Technical Service Information

THM 4L60 (700-R4) NEW WIRING HARNESS

Figure 1

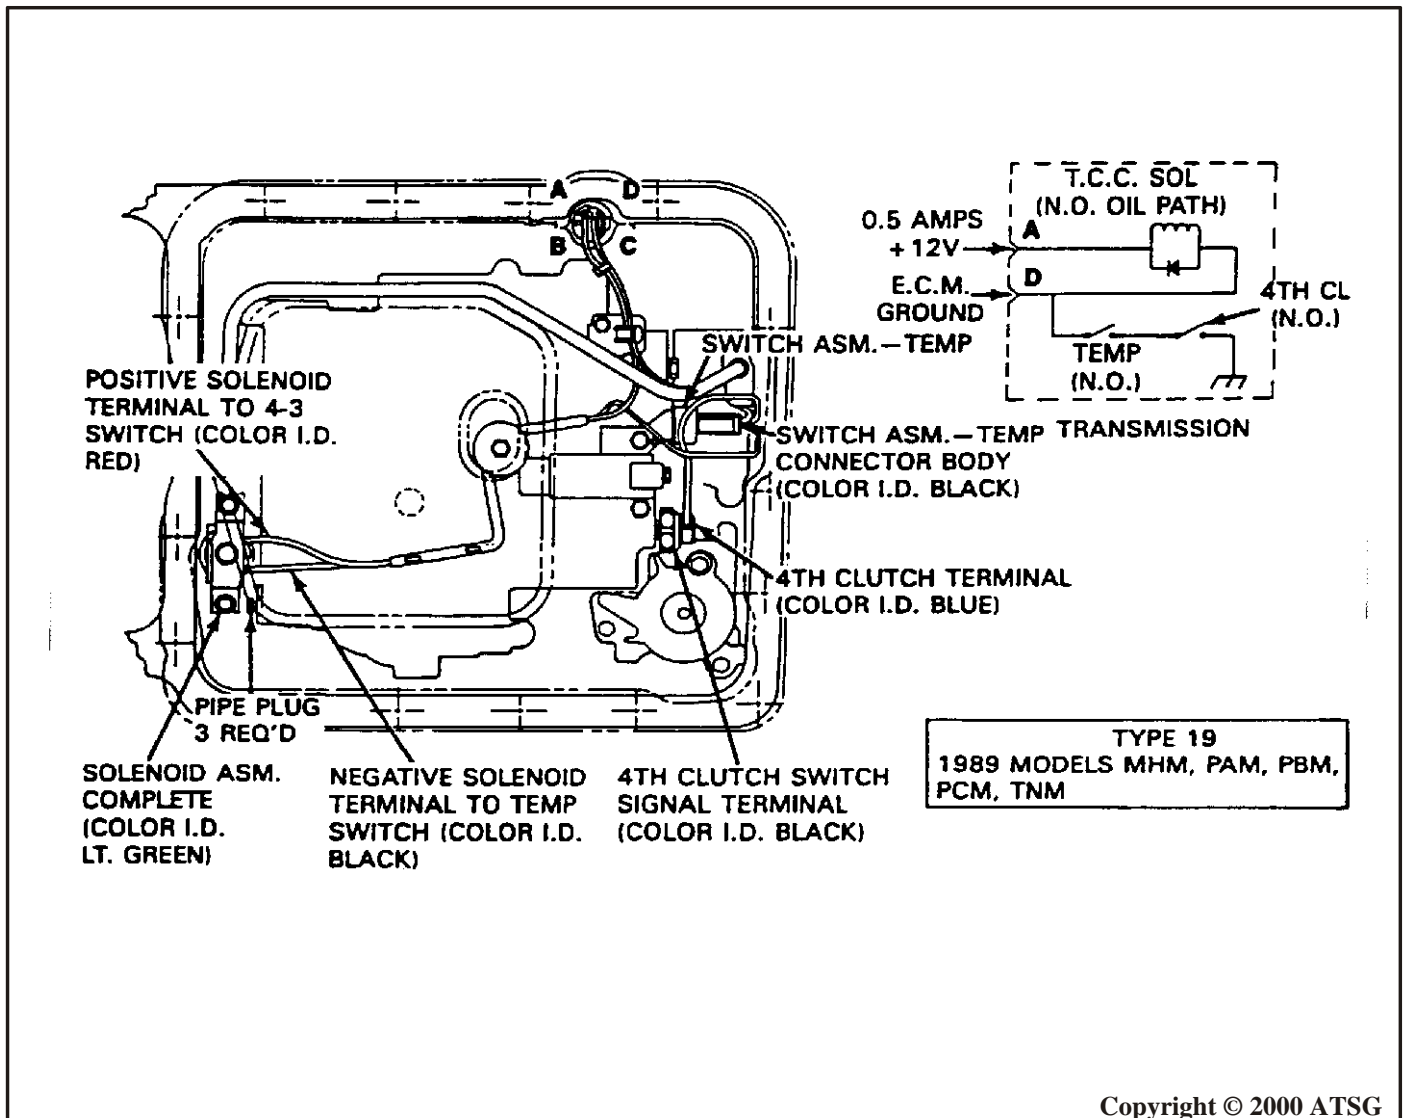
Beginning with the start of production for the 1989 model year on the THM 700-R4, the factory introduced two new solenoid assemblies, Type 19 Solenoid and Wiring Harness and Type 21 Solenoid and Wiring Harness (See Figure 1 and 2).

The Type 19 Solenoid and Wiring Harness can be identified by the "Light Green" insulator on the solenoid assembly. The Type 21 Solenoid and Wiring Harness can be identified by the "Light Blue" insulator on the solenoid assembly.

Solenoid and Wiring Harness (Type 19).....10478101
